## Revision information for DCON\_nnn.exe firmware

### A5.04[2014-Dec-11] by Martin

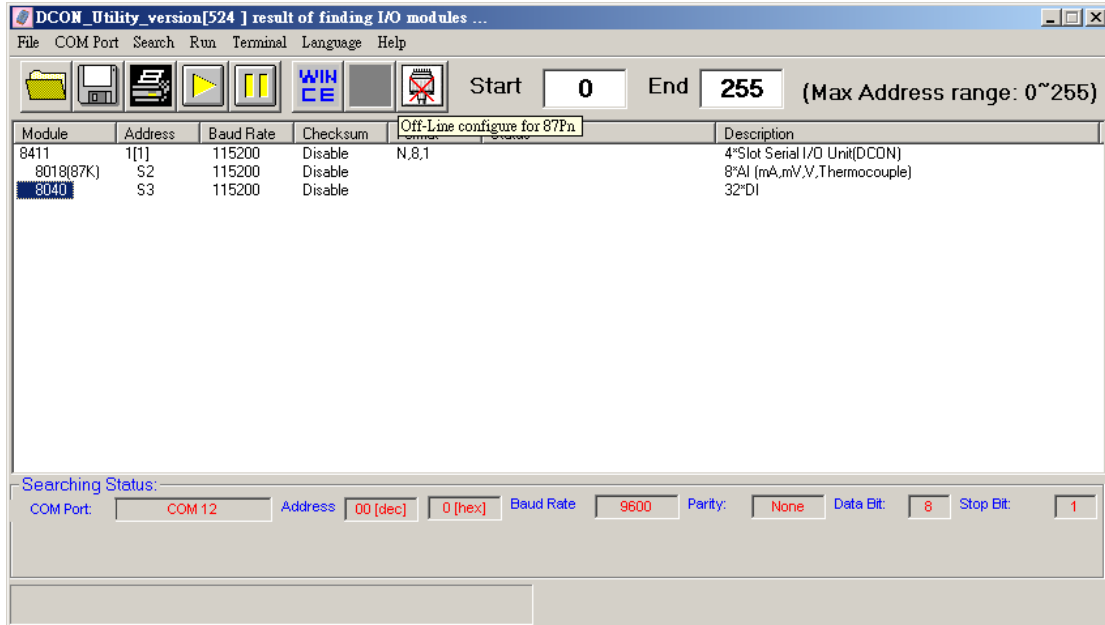
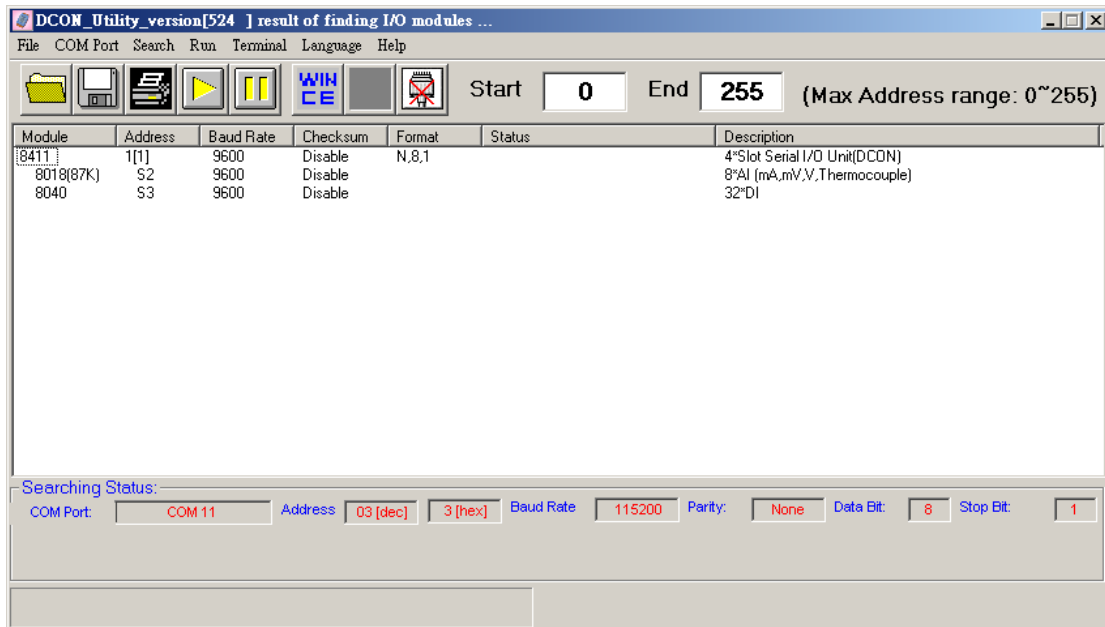
In the same time, users can configuration backplane modules via I-8410,I-8810,I-8411,and I-8811 COM1/COM2/COM3/COM4 for single or multi Host PC.

For example: Host PC1 can configure backplane I/O via i-8411 COM1 and Host PC2 also via i-8441 COM2 in the same time.

Host PC1 can configure backplane I/O via i-8411 COM1

Host PC2 also can configure backplane I/O via iP-8411 COM2 in the same time

COM1	COM2	COM3	COM4	Use all COM in the same time
Version 504 or later	OK	OK	OK	OK	OK
Previous version	OK	OK	NO	NO	NO
